Change Order

No. 1

Project: Mulberry Street Roadway and Sidewalk Improvements	Owner: Town of Shallotte	Owner's Contract No.:
Contract: Mulberry Street Roadway and Sidewalk Improvements		Date of Contract: August 7, 2024
Contractor: J.P. Russ & Son, INC.		Engineer's Project No.: 22.07019

Mulberry Street RT Wall	Exhibit
	A-1
Foundation Observations

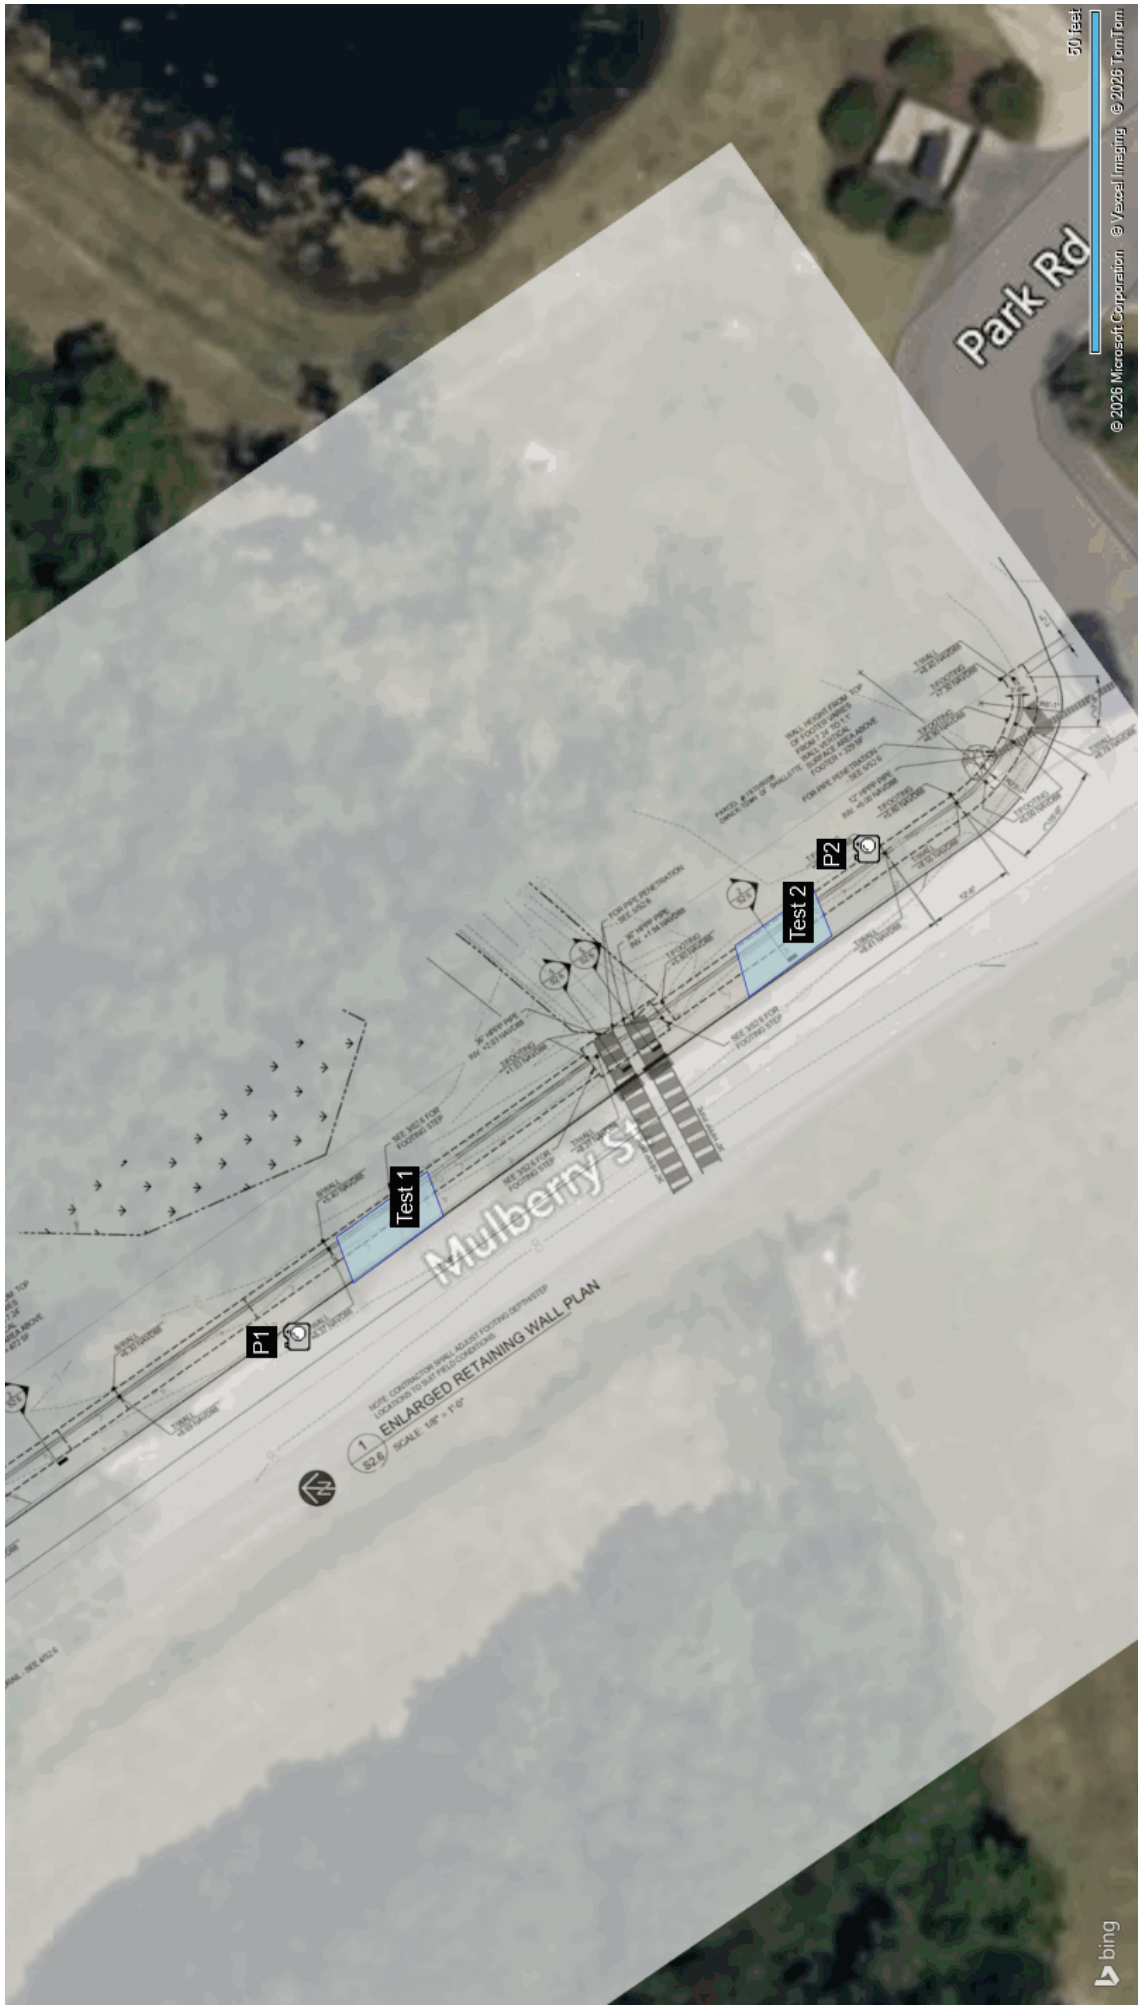
Test No./Element/ Location	Test Results	Bearing Strata	Status	Comments
(1) Continuous Footing(s)/ North end of Northwest retaining wall	BOF: 2, 2, 3 -1: 3, 3, 4 -2: 3, 6, 12 -3: 3, 6, 12	Dark Brown Silty Clay Existing Subgrade	Complies (After Remediation)	Undercut: 40' Length X 5' Width x 1' Depth = 200cf/27 = 7.4cy Geotextile Fabric: 40' Length x 1' Depth = 40sf/9 = 4.4sy (sides) x2 = 8.9sy 40' Length x 5' Width = 200sf/9 = 22.2sy (bottom)
(2) Continuous Footing(s)/ South end of Northwest retaining wall	BOF: 1, 1, 3 -1: 3, 4, 5 -2: 3, 4, 7 -3: 2, 2, 3	Moist Gray Clay Existing Subgrade	Complies (After Remediation)	Undercut: 20' Length X 5' Width x 1' Depth = 100cf/27 = 3.7cy Geotextile Fabric: 20' Length x 1' Depth = 20sf/9 = 2.2sy (sides) x2 = 4.4sy 20' Length x 5' Width = 100sf/9 = 11.1sy (bottom)

In area(s) 1 & 2, Terracon recommends a 1' undercut and replacing with washed stone with fabric on the bottom and sides of footing.
